**SUMMARY OF DISPUTED COMMENTS
ARKEMA EE/CA WORKPLAN
(2-28-06)**

Subject: Comments on Arkema draft EE/CA Workplan, dated September 26, 2005

Subject: Comments on Arkema draft EE/CA Workplan Responses

Figure 1. Arkema Site Deep Subsurface Sediment Samples > 8.0 ft

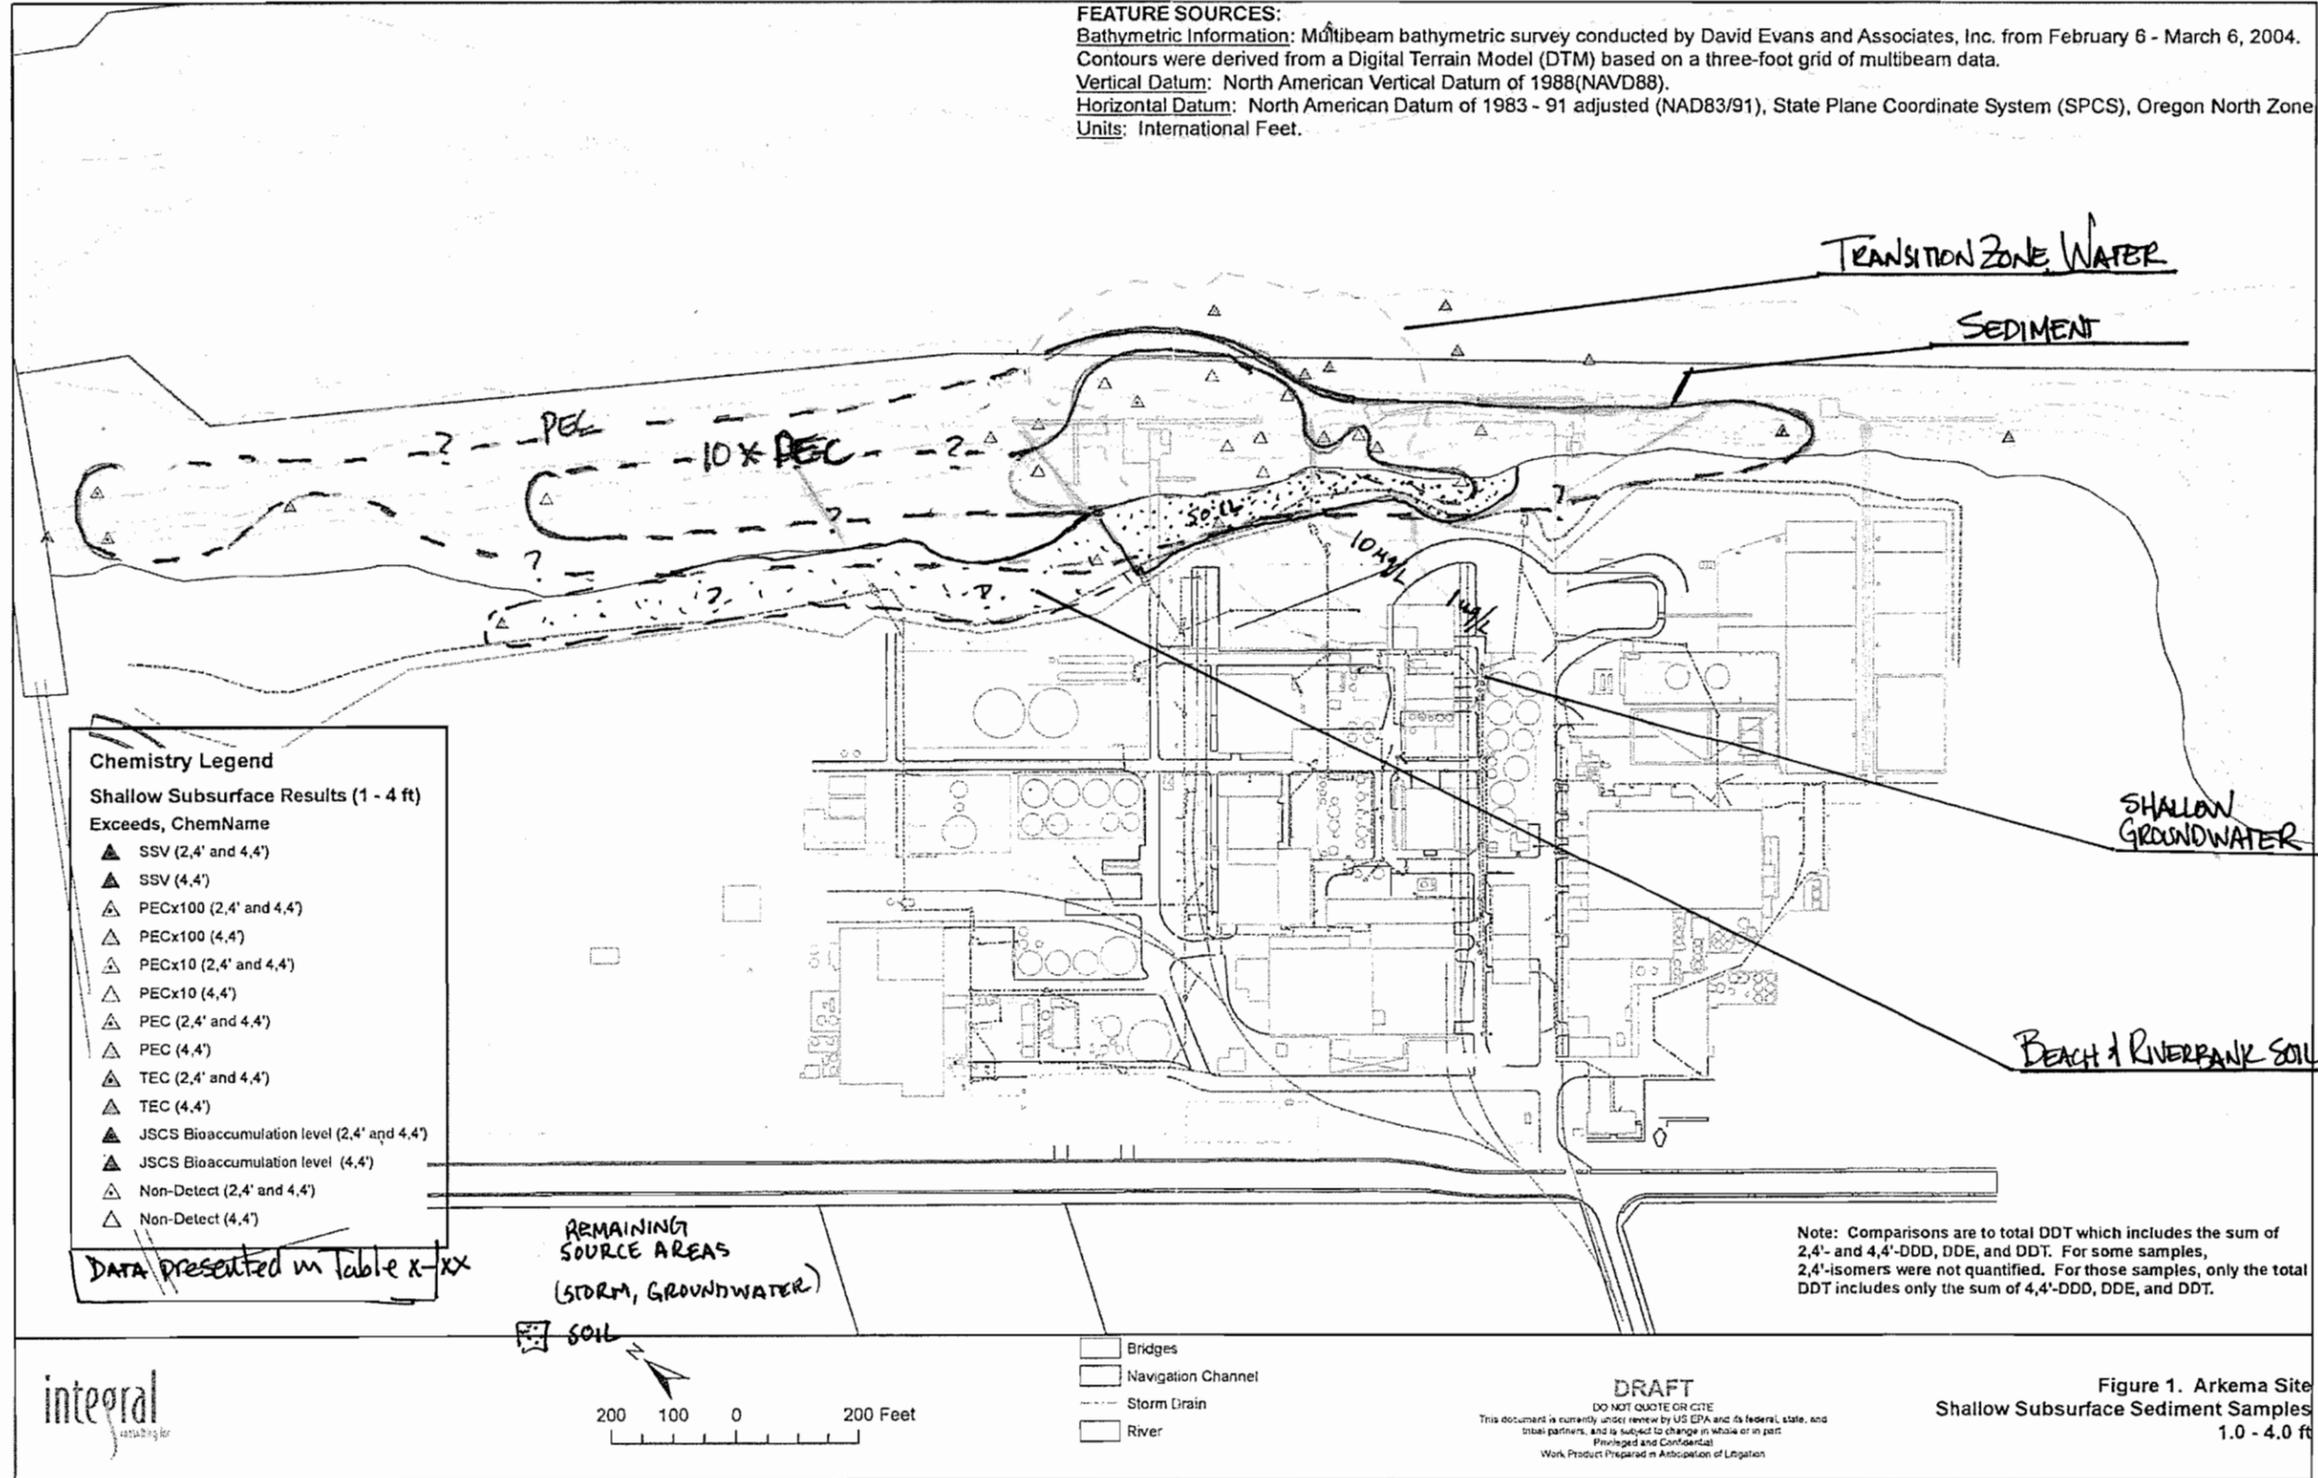
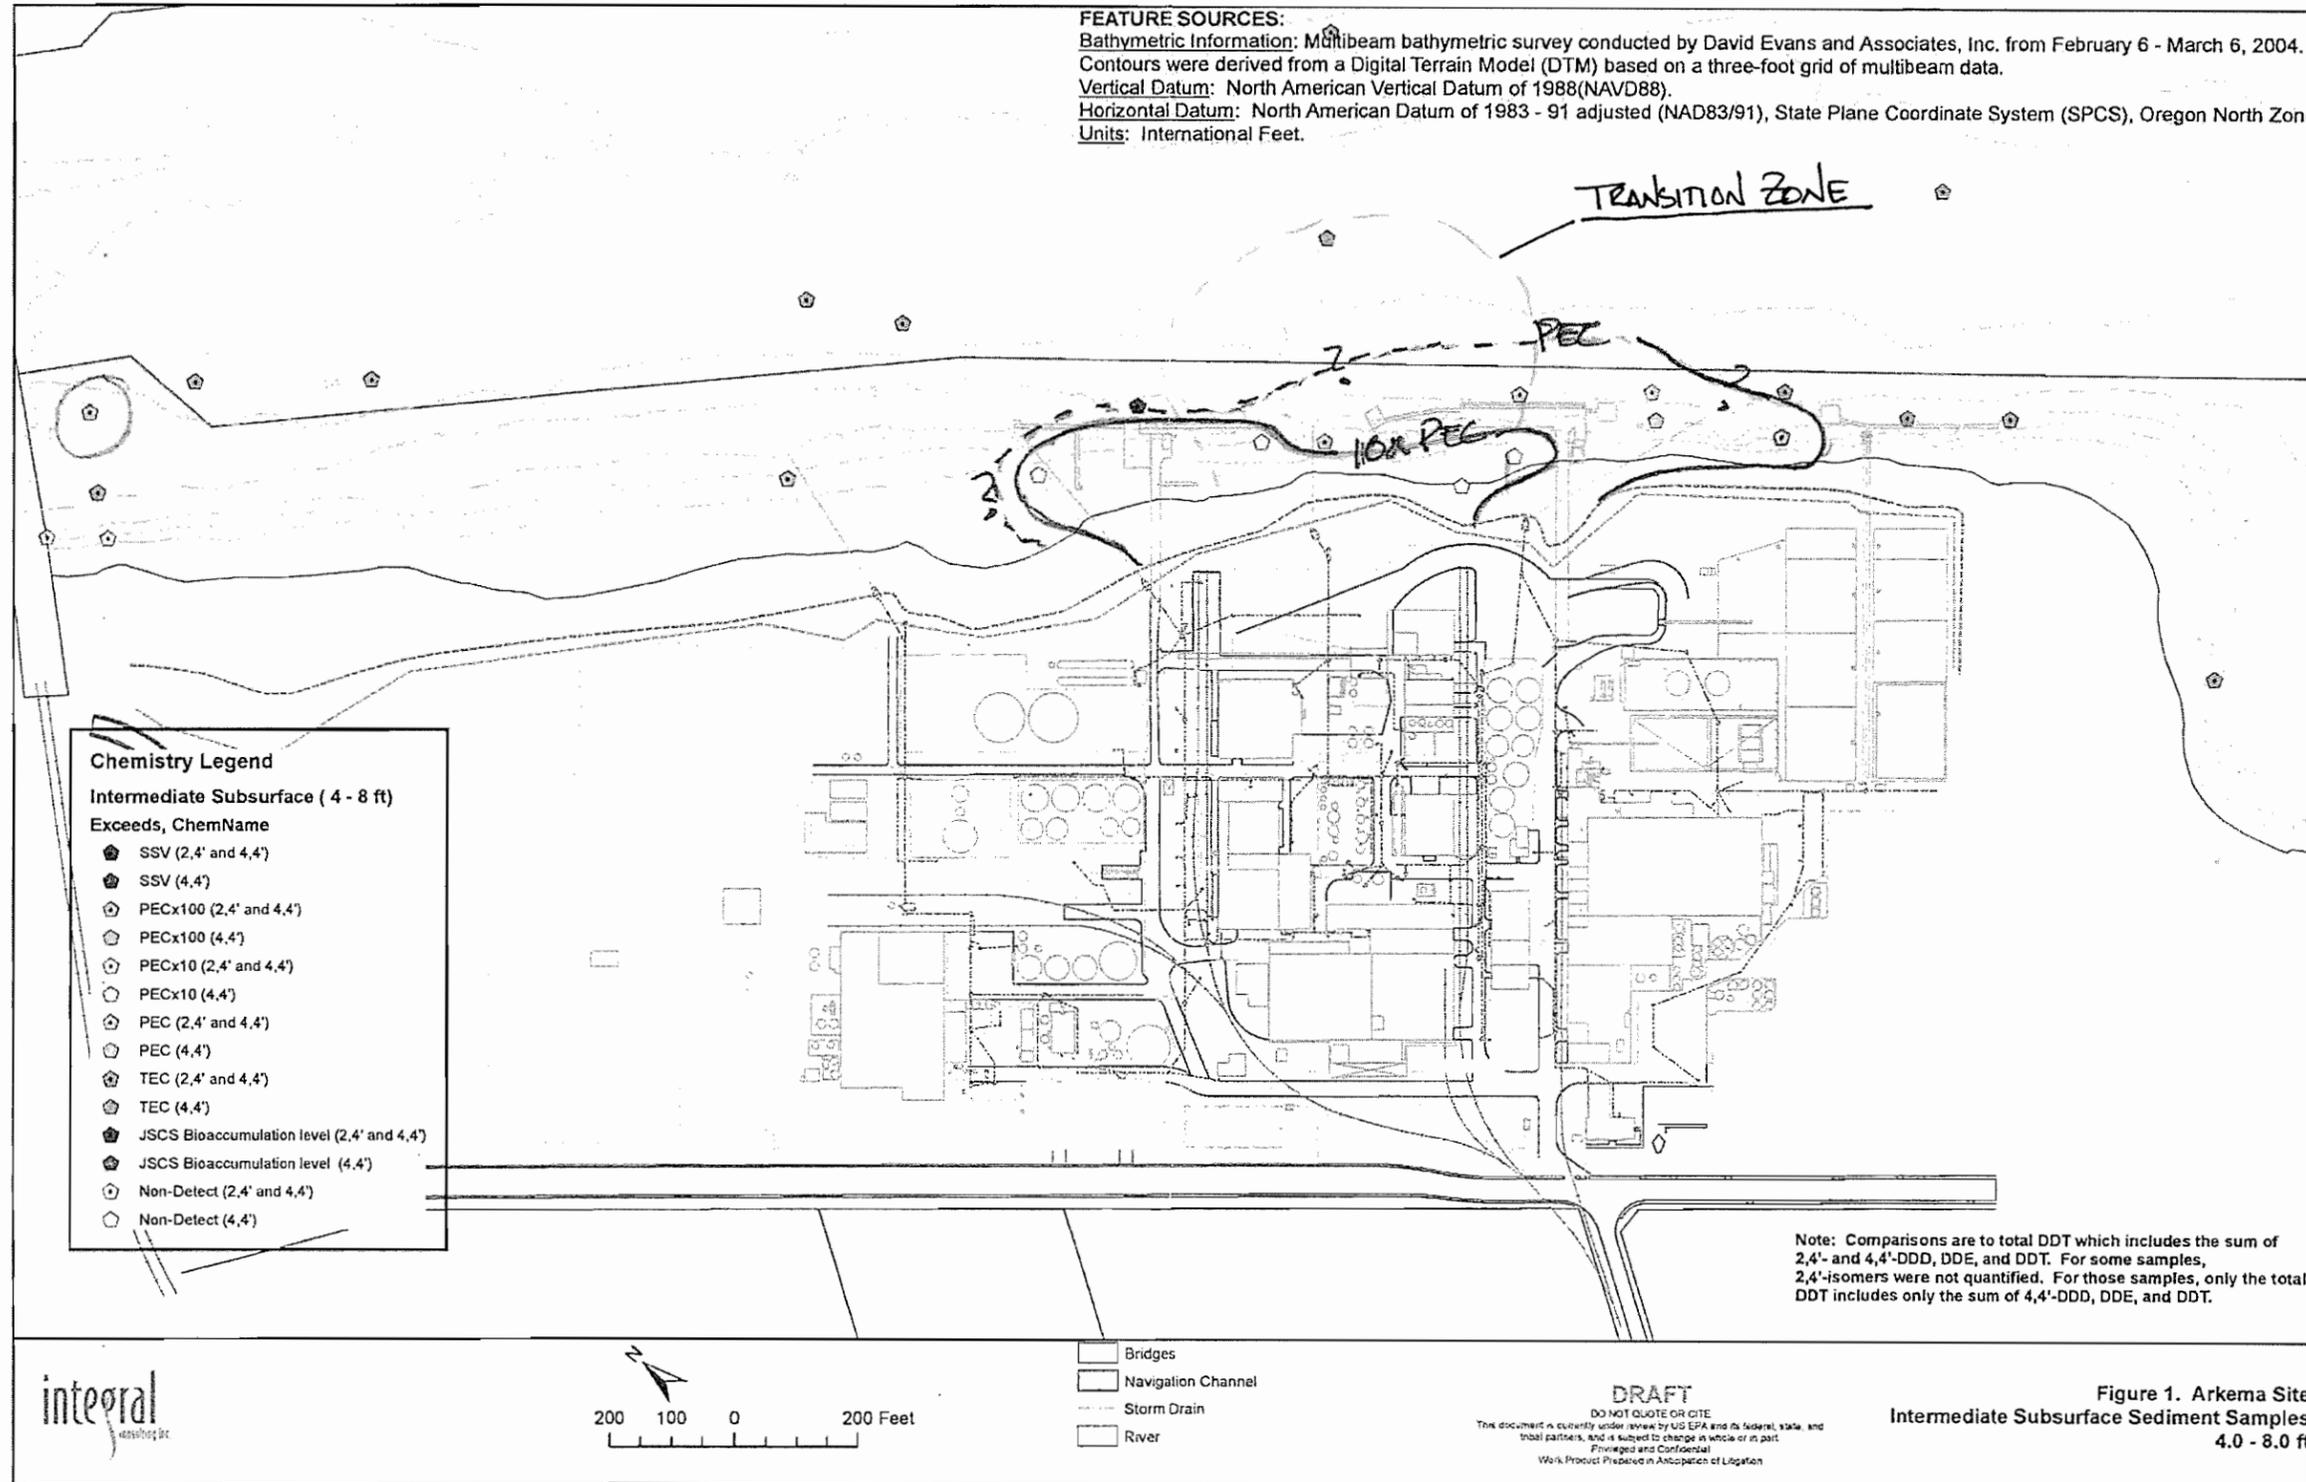
The figure examples presented on February 2, 2006 are a good start. The identification by color and symbol for different screening criteria are useful. The example figures should be expanded to show

chronic and acute screening level values as isopleths. The figures also need to show relevant upland conditions that could contribute to recontamination to and groundwater flux across the preliminary RAA. Upland information should be consistent with the upland information presented in the Upland Remedial Investigation, Lots 3 and 4 and Tract A- Revision 1.

EPA recognizes that some data sets may not meet the geo-spatial or data quantity requirements to accurately depict areal extent using iso-concentration contours. We do not expect Arkema to plot contours for data sets involving one or very few data points. EPA does expect, however that Arkema will use professional judgment to create figures that provide information suitable to identify data gaps, sampling objectives and primary risk areas for all relevant pathways.

The information should be presented in a manner that shows the relationship between upland source areas (soil, groundwater), migration pathways (surface run-off, stormwater outfalls, groundwater) and chemical distribution in the Willamette River. A rough example (conceptual) of selected information EPA would like to see on drawings is attached.
